Subject: Dresden Station Units 2 and 3
Quad Cities Station Units 1 and 2
NUREG 0737 Item III.D.3.4
Control Room Habitability Studies
NRC Docket Nos. 50-237/249 and 50-254/265

NUREG 0737 Item III.D.3.4 Control Room Habitability Study -
Revision 2 dated June 14, 1982.

PART I

PART II

DRESDEN FIGURE-1

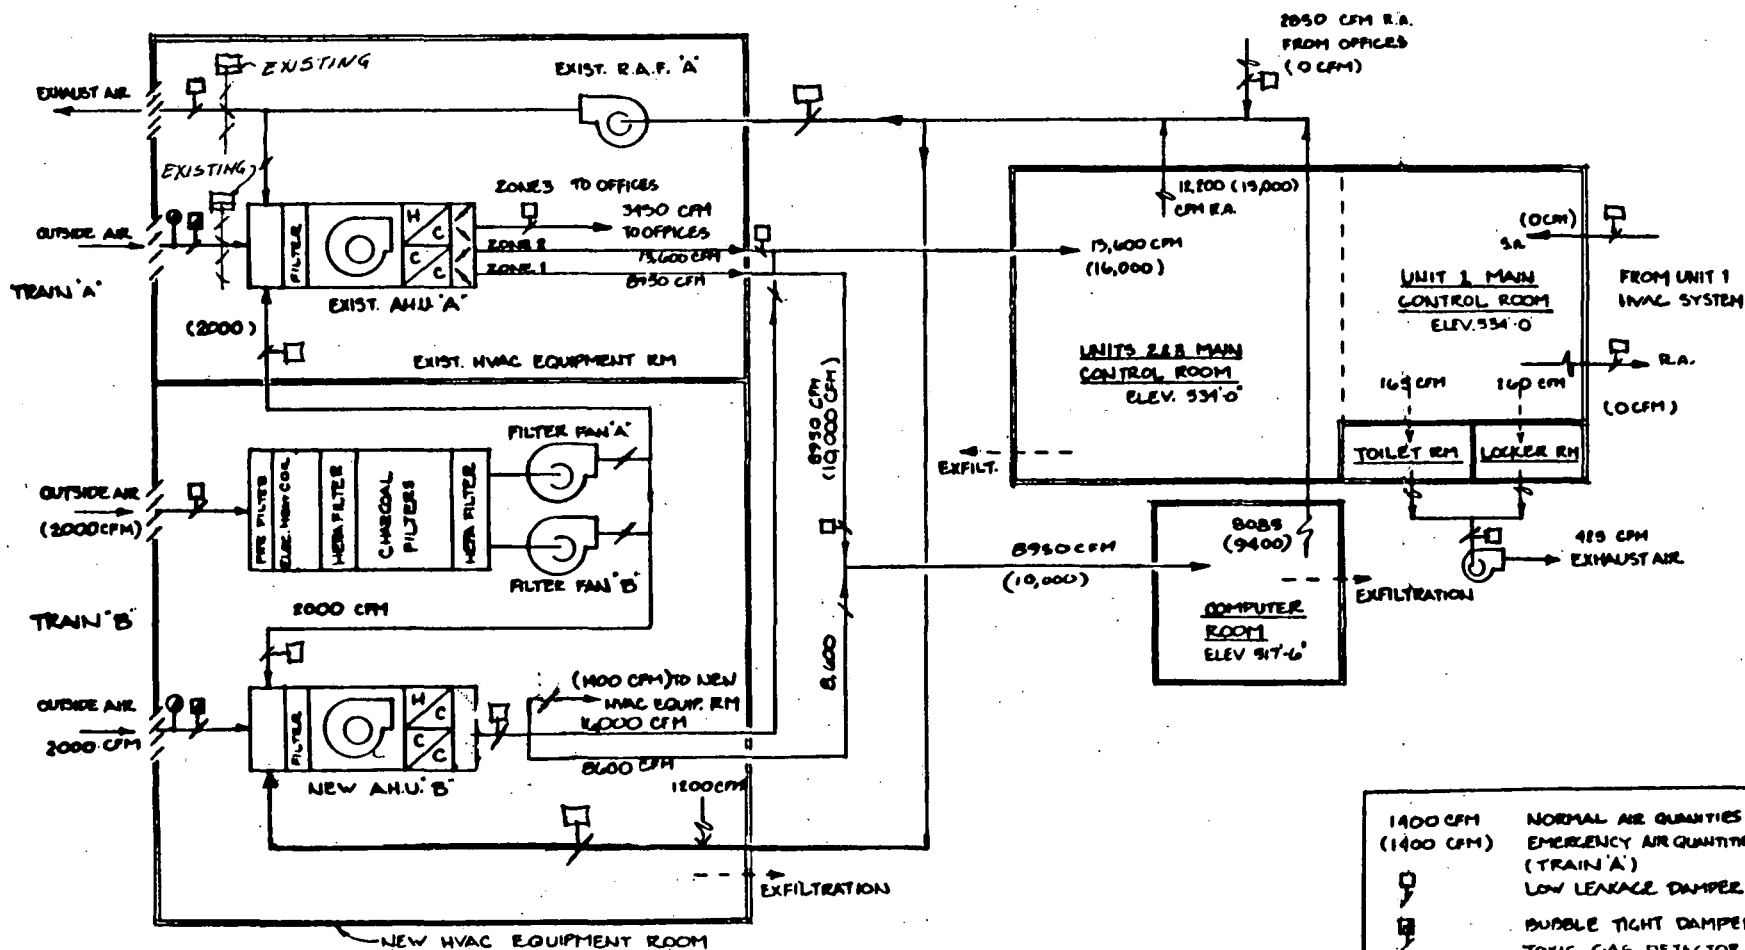
Figure 1, Revision 2 provides the schematic representation of our conceptual design. It is expected that further revisions will become necessary as P&IDs are finalized. If this activity results in a deviation from our proposed conceptual design, the NRC Staff will be so notified.

- b) The new return air fan "B" as shown on Figure 1, Revision 1 and listed as a proposed modification in paragraph 5.3.d on page 5-2 has been shown to not be required. Detailed calculations now show that the supply fan of the new air handling unit "B" has sufficient static pressure capacity to provide the required air flow in all areas. Therefore, the new return air fan "B" is no longer considered necessary and has been eliminated from our proposed modifications.

- c) Bubble tight and/or low leakage dampers will be used as deemed necessary and as conceptually shown on Figure 1, Revision 2. However, as designs are finalized, the actual configuration (use and location) may change.
